PROJECT TITLE: RANCHITOS VILLAGE ZONE ATLAS/DRNG. FILE #: D18/D13  
 DRB #: \_\_\_\_\_ EPC #: \_\_\_\_\_ WORK ORDER #: 4001.90  
 LEGAL DESCRIPTION: LOT X-1, U-A, TR-A, BLK 13, N. ALB. ACRES  
 CITY ADDRESS: RANCHITOS AVE NE  
 ENGINEERING FIRM: JEFF MORTENSEN & ASSOC. CONTACT: JEFF MORTENSEN  
 ADDRESS: 6010-B MIDWAY PARK BLVD NE PHONE: 345-4250  
 OWNER: MISS ELDERLY HOUSING CONTACT: JOSEPH GLENN  
1800 CENTURY BLVD - SUITE 1260  
 ADDRESS: ATLANTA GA 30345 PHONE: 404-321-0232  
 ARCHITECT: WHITNEYBELL ARCHITECTS CONTACT: DOUG WHITNEYBELL  
1102 E. MISSOURI AVE.  
 ADDRESS: PHOENIX, AZ 85014 PHONE: 602-265-1891  
 SURVEYOR: JEFF MORTENSEN & ASSOC. CONTACT: JEFF MORTENSEN  
 ADDRESS: 6010-B MIDWAY PARK BLVD NE PHONE: 345-4250  
 CONTRACTOR: BRADBURY & STAMM CONTACT: GINA ZAMORA  
 ADDRESS: \_\_\_\_\_ PHONE: 765-1200

RE: ENGINEER'S CERTIFICATION FOR RANCHITOS VILLAGE  
(MISS HANDICAP HOUSING) (D-18/D13) CERTIFICATION  
STATEMENT DATED FEBRUARY 19, 1991

ENGINEER'S CERTIFICATION  
RANCHITOS VILLAGE

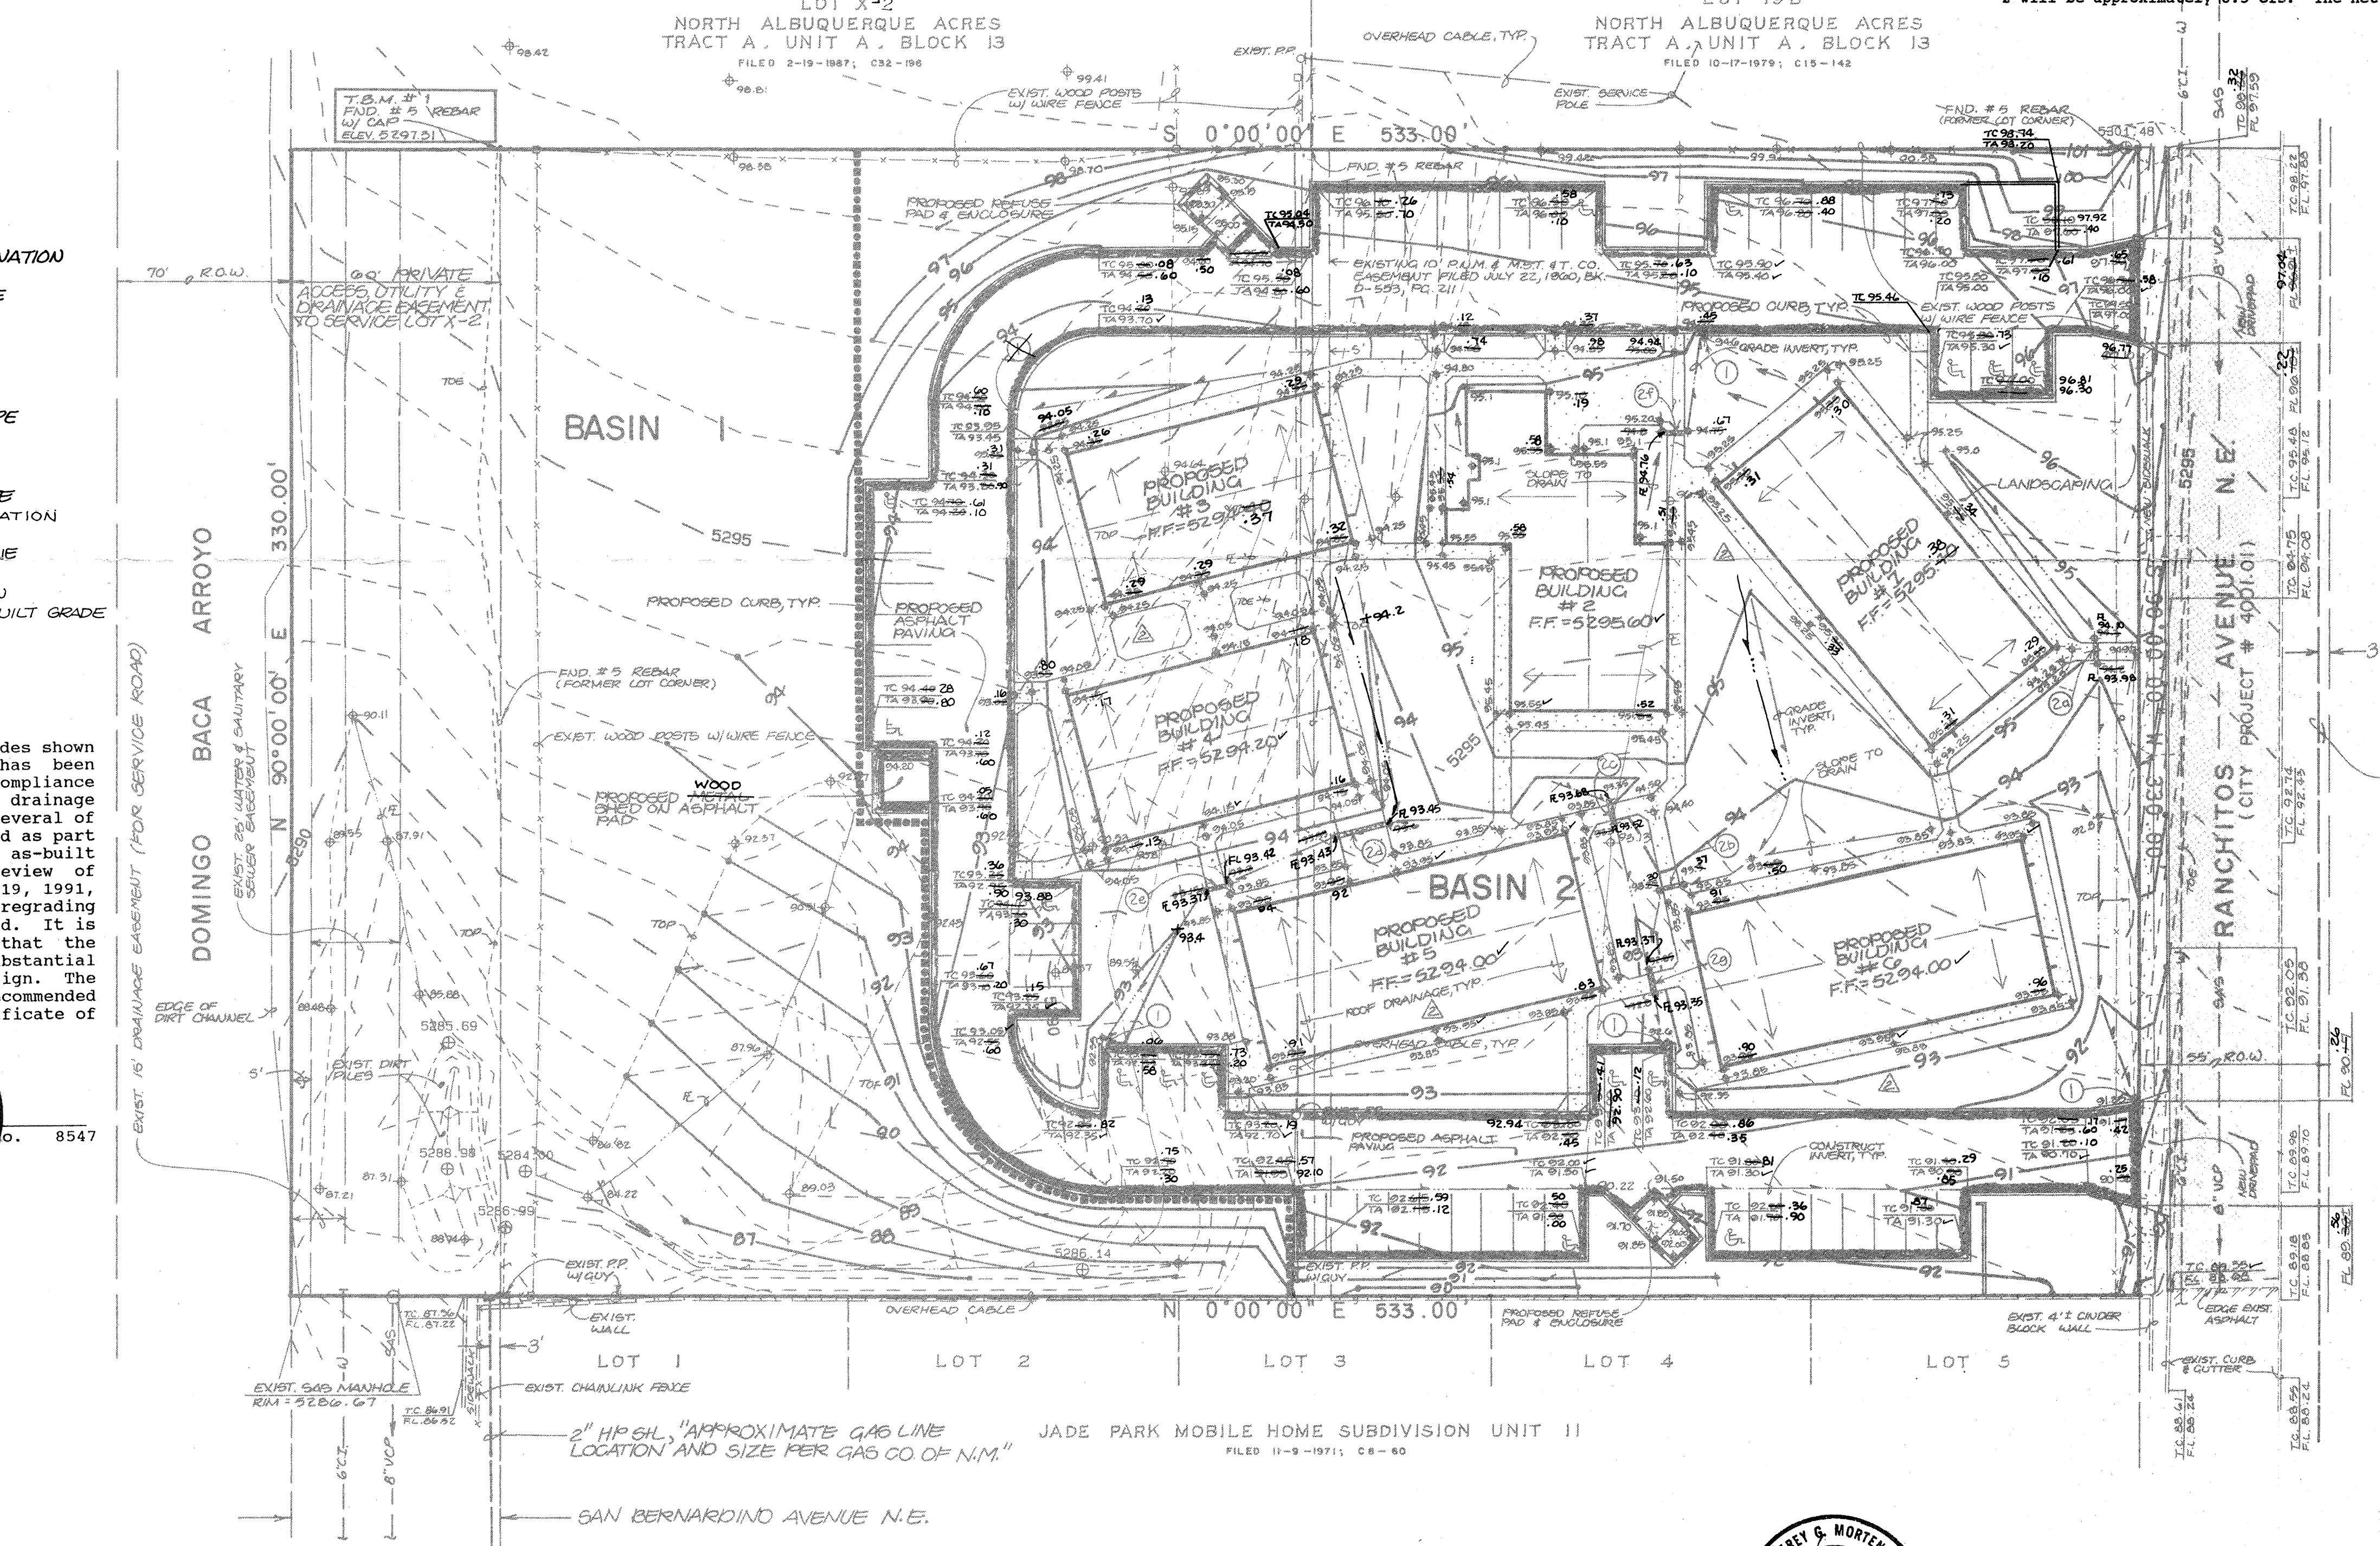
Based on the information provided on your submittal of February 20, 1991,  
Certification for the referenced site is acceptable.
